RM007 Mr and Mrs Thompson's objection to the Environment Agency's Application to vary the Scheme within the River Medway (Flood Relief) Act 1976

Environment Agency technical response, September 2020

Figure 6: Increase in flood depth in a 1.33% flood event. 28.05m AOD vs 28.6m AOD

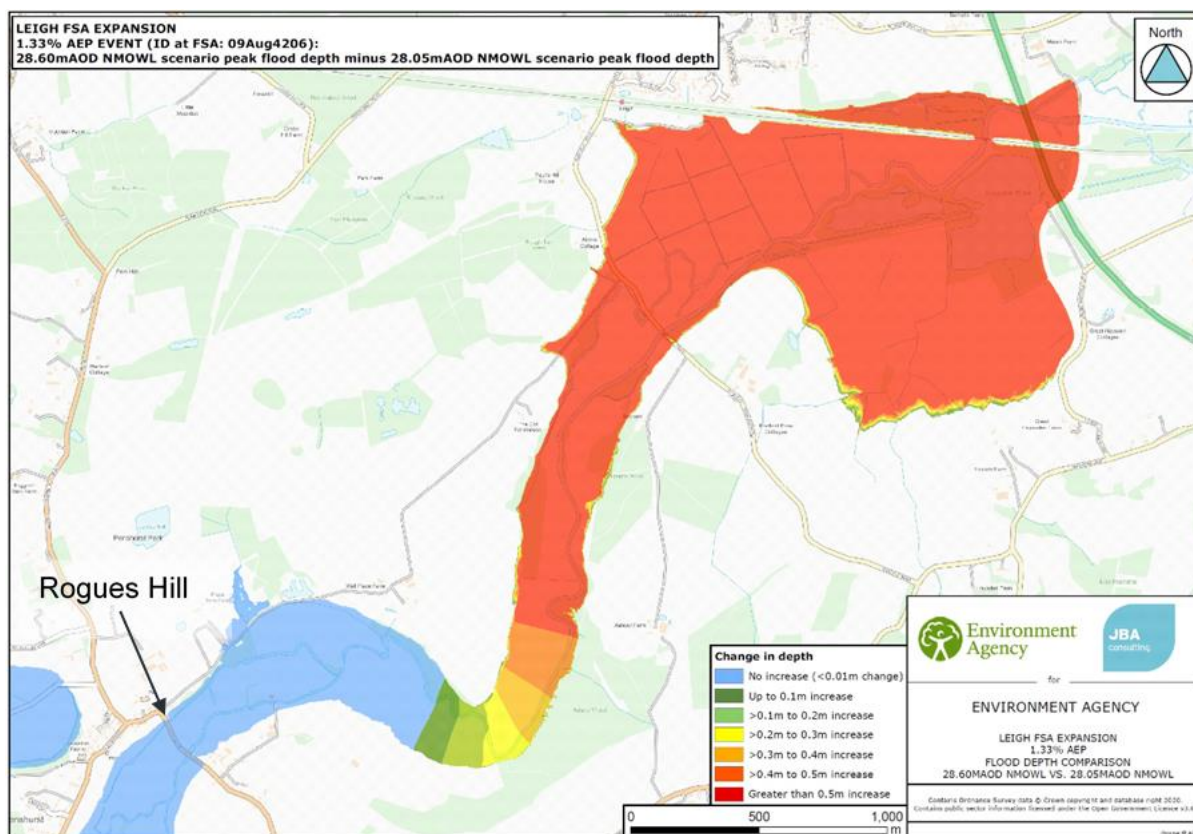
6.2 Prior to the last year, the EA have constantly referred to the 1 in 100 years plus climate change as the scenario to be defended against. It was also frequently stated that this was the scenario used in their plans. In the current application, the EA have suddenly changed this to a 1 in 75 year scenario.

Why the change? Particularly as it is contrary to the national guidance. With at least 3 major floods in the last decade, the EA have clearly got a much more frequent issue to attend to.

Whilst the 2015 Medway flood model indicates that in certain circumstances, operation of the FSA can add up to 0.1m to the depth of flood water at The Yews, the flood model also indicates that the proposed change to increase the maximum impoundment level will not further increase the depth of flooding at The Yews.

This is illustrated in Figure 6 below. Figure 6 shows the increase in flooding depth from raising the Leigh FSA maximum impoundment level from 28.05 mAOD to 28.6 mAOD (measured at the main Leigh FSA embankment) during a 1.33% flood event. The map below has been taken from the Flood Risk Assessment for consistency. This map has been updated since the submission of the Application. Whilst it shows greater depth variation lower in the FSA, the point at which the effect of the expansion dissipates remains the same.

Every flood event is different, depending on a number of factors, including soil saturation and weather patterns. The modelled scenario in Figure 6 was chosen to demonstrate the impact of expanding the FSA because it shows the greatest change in flood depths.

Figure 6 in our response to point 1 shows a plan of the additional depth of water during a modelled 1.33% (1 in 75 year) flood event as a result of changing the maximum stored water level from 28.05m AOD to 28.6m AOD.

We chose this scenario to demonstrate the impact of expanding the FSA because it shows the greatest change in flood depths as a result of the proposed change. The depth increase for the majority of the storage area will be greatest for the 1.33% event.

During more extreme flood events, such as a 1% (1 in 100 year) plus climate change event, the increase in depth as a result of the proposed change reduces. This is because the natural flood level, which is greater, dominates.
